Attachment 1

Technical Specification Changed Pages  
in Support of the Pressure/Temperature Limits Report.

Example of the Pressure/Temperature Limits Report

**PRESSURE/TEMPERATURE LIMITS REPORT**

WNP-2 Pressure/Temperature Limits curve C of the  
PRESSURE/TEMPERATURE LIMITS REPORT

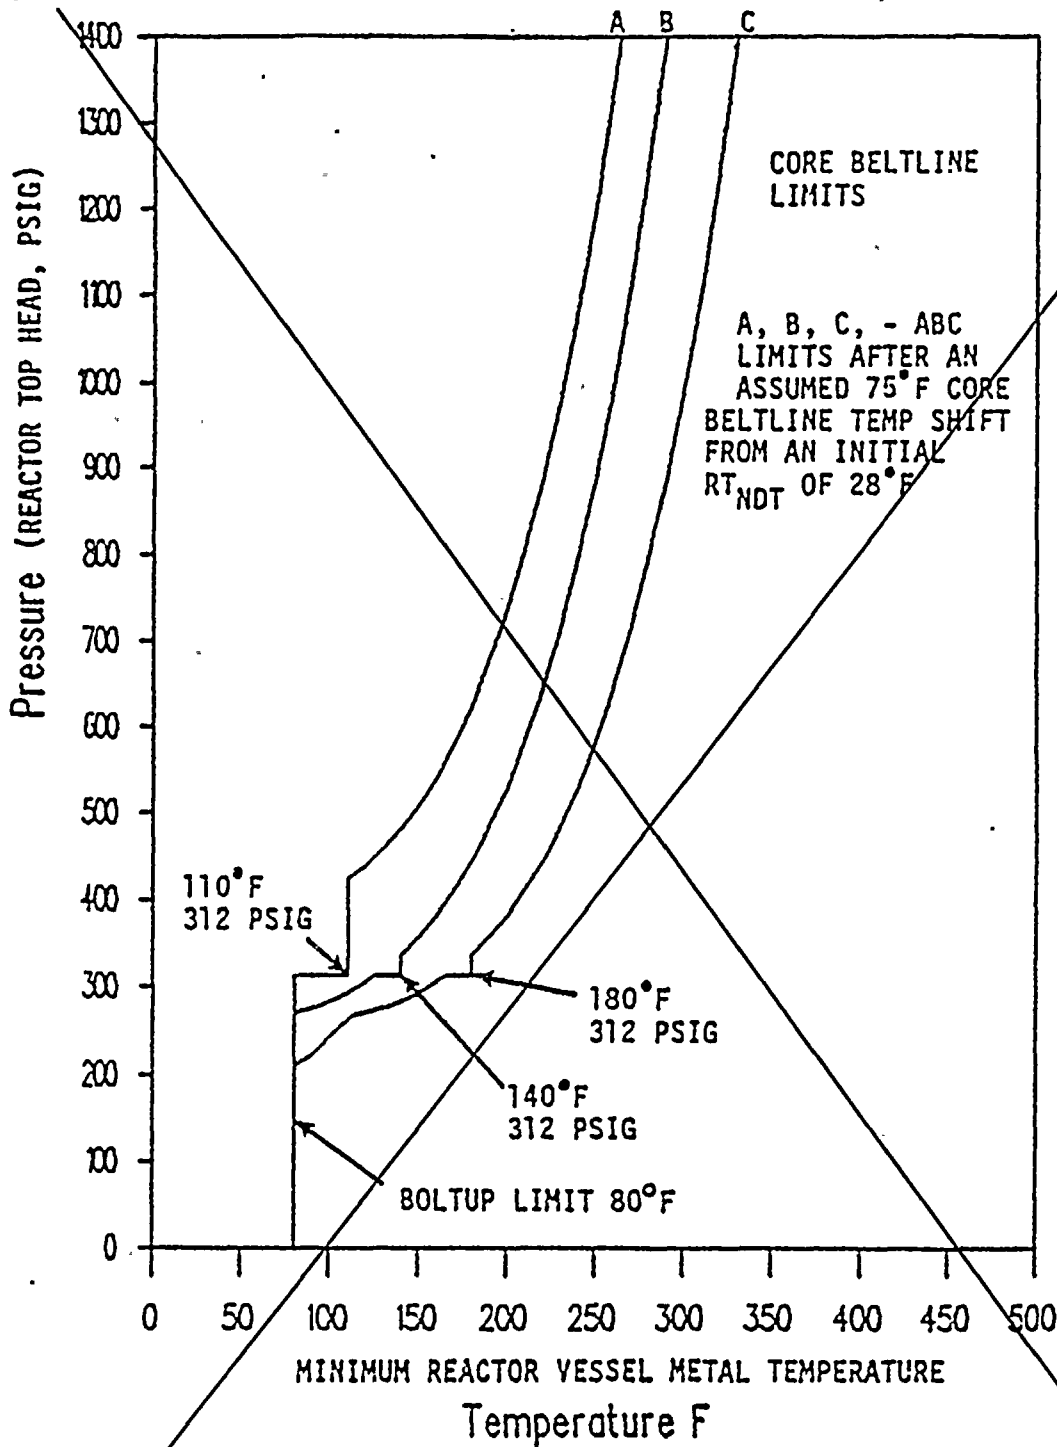
4.4.6.1.2 The reactor coolant system temperature and pressure shall be determined to be to the right of the ~~criticality limit line of Figure 3.4.6.1 curve C~~ within 15 minutes prior to the withdrawal of control rods to bring the reactor to criticality and at least once per 30 minutes during system heatup.

4.4.6.1.3 The reactor vessel material surveillance specimens shall be removed and examined, to determine changes in reactor pressure vessel material properties as required by 10 CFR Part 50, Appendix H in accordance with the schedule in ~~Table 4.4.6.1.3-1~~. The results of these examinations shall be used to update the curves of Figure ~~3.4.6.1-1~~ of the PRESSURE/TEMPERATURE LIMITS REPORT. NRC approved
